Access Compliance Report

Public Rights-of-Way

(Curb Ramps)

Intersection ID: 27102	Main Street: ANDREWS_LINKS_ST	Cross Street: STEWART_RIDGE_ST	Location: NE
ADA ID: 8F026FCD3164	Ramp Type: Perpendicular Diagonal	Initial Pass/Fail: Fail	Overall Compliance: No
Severity Score: 46.25			
Codes/Mitigation Info/Possible Solution		Field Measurements/Component Compliance

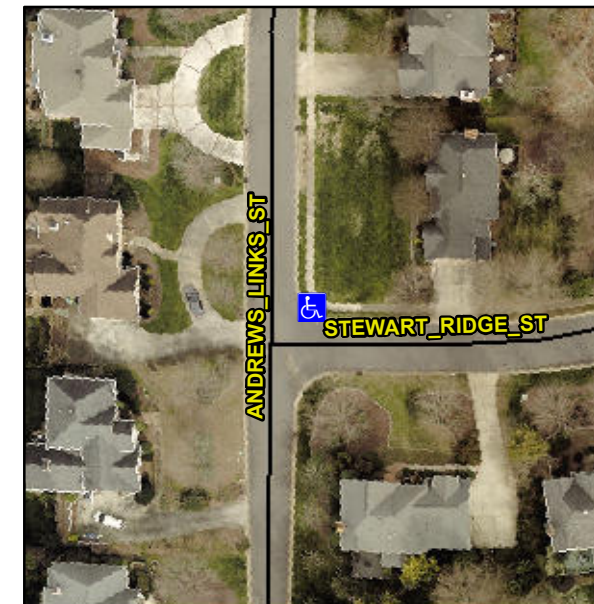
R304.5.1, R304.2.2, R304.5.3

Compliance	Description	Data	Compliance	Description	Data
N/A	Ramp Length (in)	96.5	No	Ramp Slope (%)	10.4
No	Ramp Width (in)	44.5	No	Ramp XSlope (%)	10.3
N/A	Flare Type LT	N/A	N/A	Flare Type RT	N/A
N/A	Flare Slope LT (%)	N/A	N/A	Flare Slope RT (%)	N/A
N/A	Flare Traversable LT?	N/A	N/A	Flare Traversable RT?	N/A
N/A	Landing Length (in)	N/A	N/A	DWS Provided?	N/A
N/A	Landing Width (in)	N/A	N/A	DWS Contrast?	N/A
N/A	Landing Slope (%)	N/A	N/A	DWS Length (in)	N/A
N/A	Landing X Slope (%)	N/A	N/A	DWS Full Width?	N/A
N/A	Landing Curb? (Y/N)	N/A	N/A	DWS Offset (in)	N/A
N/A	Shared Landing?	N/A			
N/A	Gutter Ponding?	N/A	N/A	Gutter Slope (%)	N/A
N/A	Gutter Lip Ht (in)	N/A	N/A	Gutter X Slope (%)	N/A
N/A	Painted X Walk1?	No	N/A	Painted X Walk2?	No
	X Walk 1 Direction	To W		X Walk 2 Direction	To S
N/A	X Walk 1 Width (in)	N/A	N/A	X Walk 2 Width (in)	N/A
	X Walk 1 Slope (%)	6.2		X Walk 2 Slope (%)	1.4
	X Walk 1 X Slope (%)	3.6		X Walk 2 X Slope (%)	7.1

N/A	Ramp inside XWalk1?	N/A	N/A	Ramp inside XWalk2?	N/A
	Road Slope (%)	8.1	N/A	Clear Space?	N/A
	Road X Slope (%)	0.8	N/A	Clear Space to XWalk (in)	N/A
N/A	Any Obstructions?	N/A	N/A	Storm Grate/Utility Hazard?	N/A
	Obstruction Type			Storm Grate/Utility Type	
		N/A			N/A
			Yes	Surface Condition? (G/P)	Good

Remove & Replace Curb Ramp With Two New Directional Ramps or Equivalent.
